PLANNING SUB COMMITTEE

Monday, 3rd July, 2023, 7.00 pm - George Meehan House, 294 High Road, Wood Green, London, N22 8JZ (watch the live meeting [here](#), watch the recording [here](#))

REPORT FOR CONSIDERATION AT PLANNING SUB-COMMITTEE

Proposal: Full planning permission for the refurbishment and extension of Berol House to include Use Class E floorspace; and the redevelopment of 2 Berol Yard to provide new residential homes and Use Class E floorspace; with associated landscaping, public realm improvements, car and cycle parking, and other associated works.

Figure 6-12 Interim Car Parking Provision

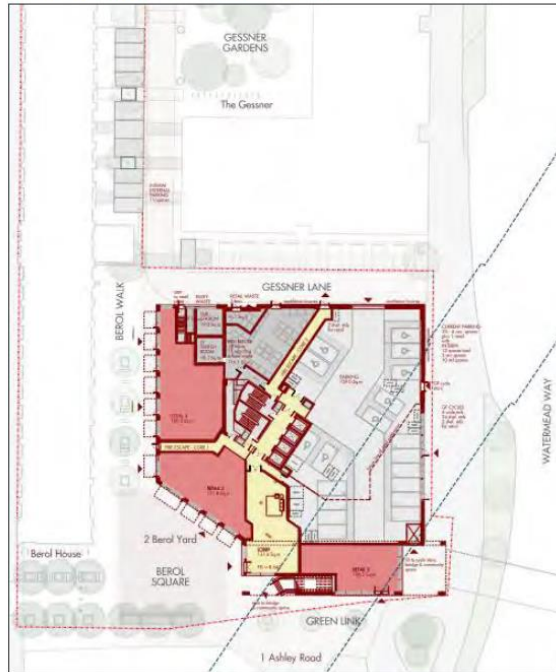
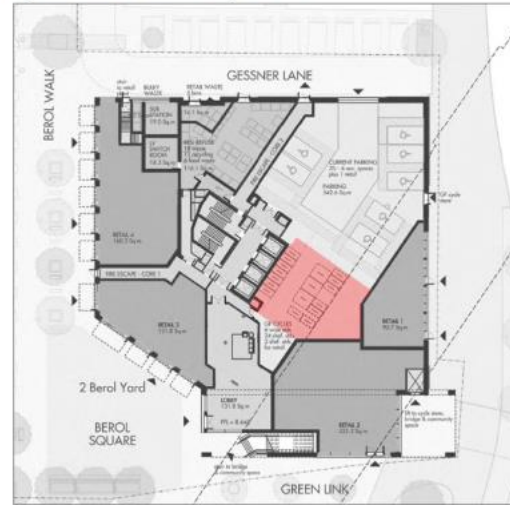
- c. Regarding Figure 6.12 and Figure 6.6 – Are the car parking spaces and the cycle parking both at ground floor levels or different levels?
- d. Regarding provision of Club bays, the current proposals are significantly different from those previously considered under Planning Ref: HGY/2017/2044. The TAR should assess / review the existing and committed demands for car club vehicles and demonstrate adequacy of provision of car club vehicles / capacity, to service the cumulative demands including from additional residential development proposals. A detailed proposal will be required.

| | <p>cycle parking layout with dimensioned plans that complies with LCDS, are required.</p> <p>d. The proposals for 2 Berol Yard will be car free except for provision for 'Blue Badge' car parking. This will initially include 3% provision for 6 'Blue Badge' holder parking spaces required for the residential units and one space for retail use. London Plan requirement for 10% of dwellings to be accessible and have parking spaces is not subject to reduction by reference to data from other sites. A parking management plan will be required to set out how this level of provision will be provided.</p> <p>The proposals for Berol House will include provision for one Blue Badge parking space. However, there will be 30 standard car parking spaces retained for existing tenants with contractual rights.</p> <p>The provision of one 'Blue Badge' parking space for the commercial use (5209m2 GEA) is not considered adequate. Further detailed assessment is required using number of employees / multiple occupiers and statistics of percentage of working age people with 'Blue Badge' permits.</p> <p>Clarification is required regarding the overlaps in layout of interim retained 30 car parking in Fig.6.12, the cycle parking illustrate at Figure 6.6 and the vehicular swept path for a refuse vehicle, below.</p> | |
